Sail Auxiliary — D-7 Group No. 13 Fuel System	June 9, 1981	Bulletin No. 13003 (1005)

Subject: **Fuel System on D-7 Engine**

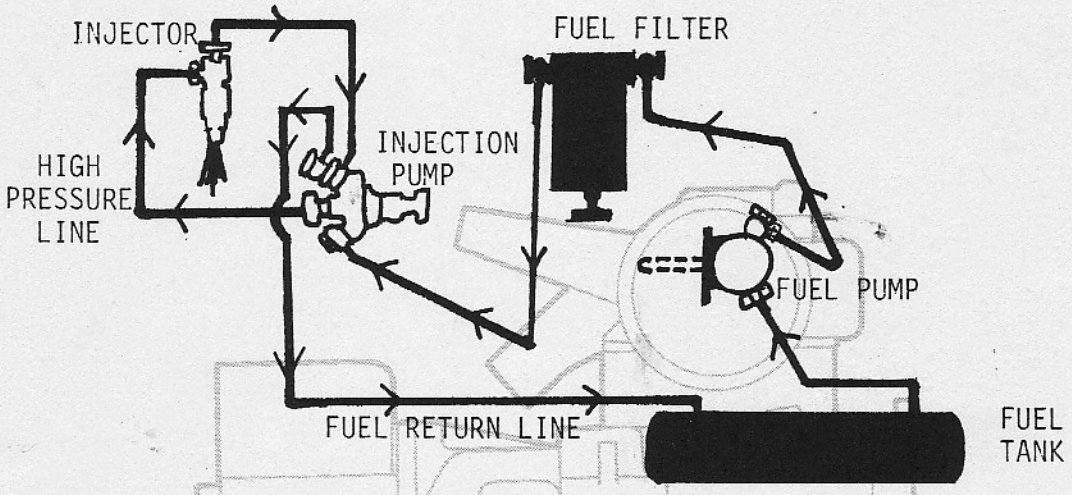
To clarify the proper sequence for the D-7 fuel routing system we have diagrammed the proper sequence below. Please check the position of **ALL** connections!

Please check all boats with the BMW D-7 engine to insure that the fuel routing on the boat conforms with the fuel routing diagram. The performance of the engine is dependent upon the proper supply of fuel through the system.

After you have changed the fuel line routing, bleed the fuel system as follows:

1. Turn the air bleed screw at the fuel filter housing out three turns.
2. Pump the fuel using the manual pump lever on the side of the fuel pump until clear fuel comes from the air bleed screw.
3. Tighten air bleed screw.
4. Start engine and check fuel connections.
